# **Building Code of Australia**

## **Assessment Report**

**Project Address: 1 Alfred Street, Sydney**

Report Number: 152779 – Tower B

Number of exits required (D1.2)

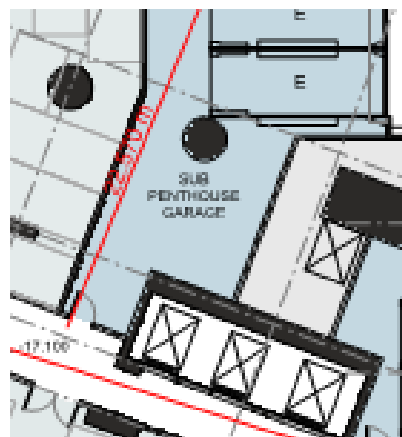
Retail tenancies on the Ground Floor do not have access to two exits

### Basement 1

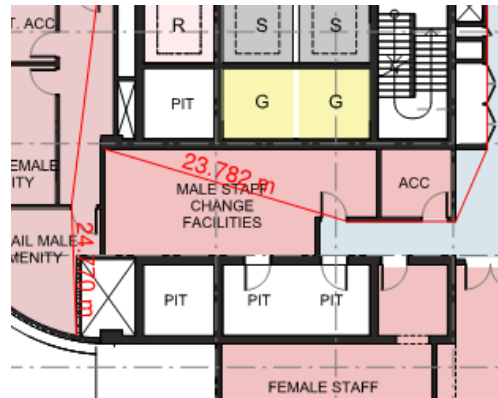
- i. Distance to a point of choice from Retail Male Amenity and Male Change Facilities is more than 20m (24m).

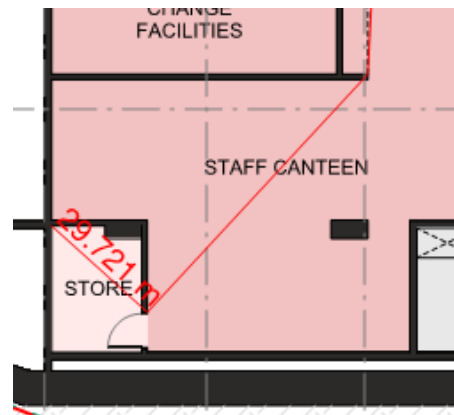
- ii. Distance to point of choice from Store in Staff Canteen exceeds 20m (29m).

### Ground Mezzanine

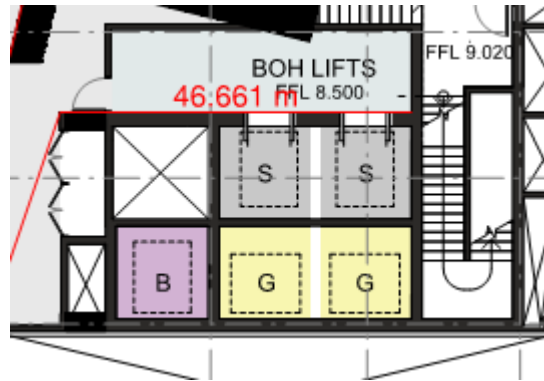
Distance to the exit from BOH Lifts exceeds 40m (47m)

#### Level 2

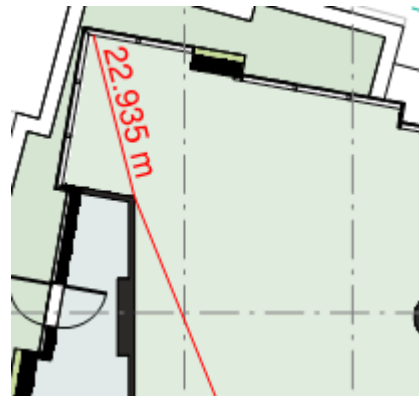
Distance to a point of choice from the Ballroom exceeds 20m (23m).

#### Level 4 to 19

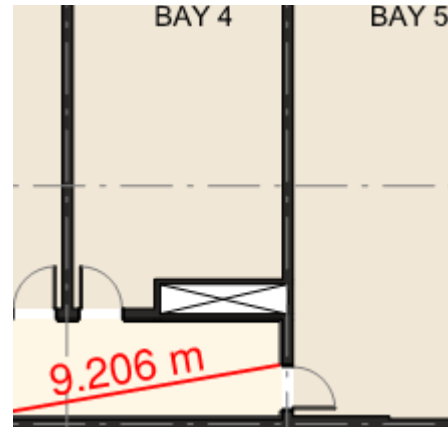
Distance to a point of choice from Bays 1 and 5 exceeds 6m (9m).

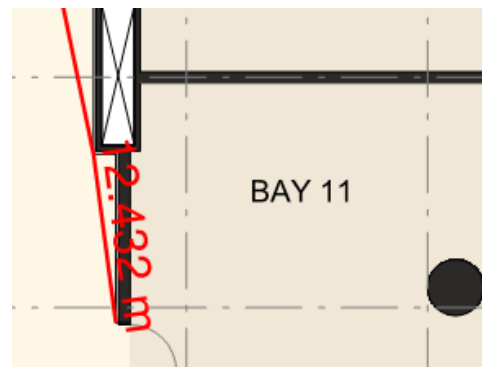
Distance to a point of choice from Bay 11 & 12 exceeds 6m (12m).

#### Level 20 & 21

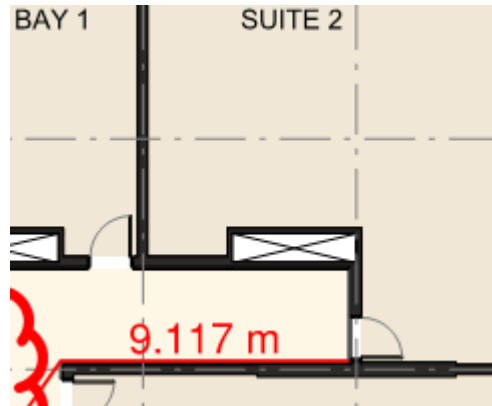
Distance to a point of choice from Suites 1 & 2 exceeds 6m (9m).

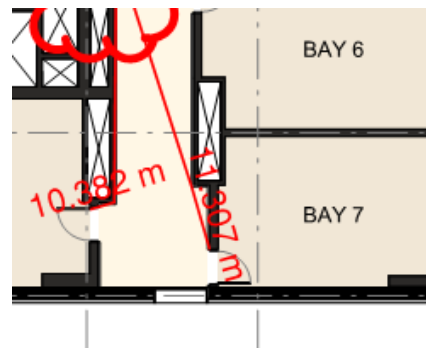
Distance to a point of choice from Bays 7 and 8 exceeds 6m (12m).

#### Level 22

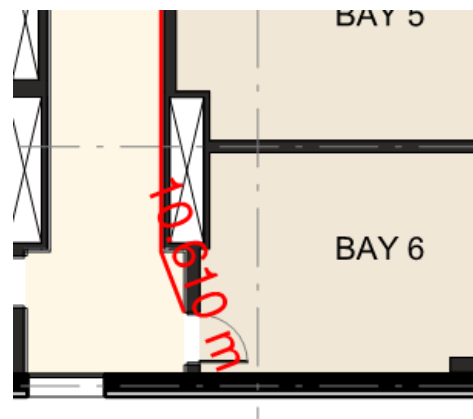
Distance to a point of choice from Bays 6 and 7 exceeds 6m (11m).

#### Level 24

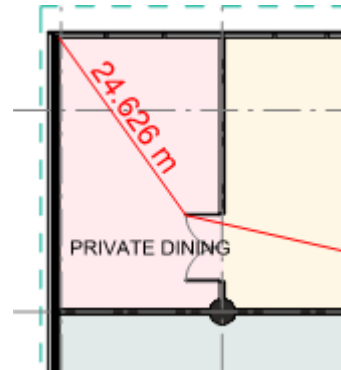
Distance to a point of choice from Private Dining exceeds 20m (25m).

#### Ground Mezzanine

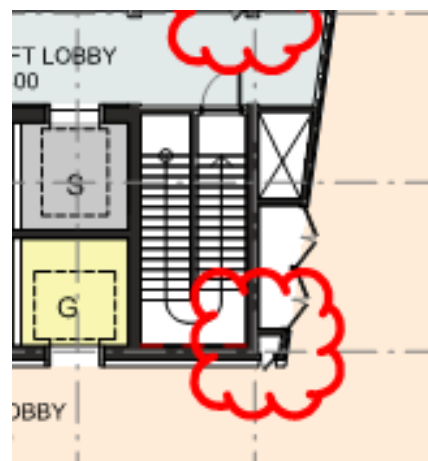
Distance between alternative exits exceeds 60m (78m)

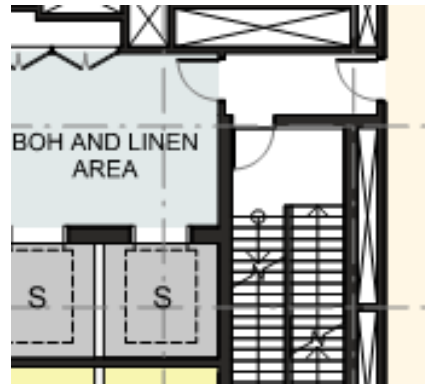
- ii. Levels 4 to 23 BOH Linen Area opens directly to stair.
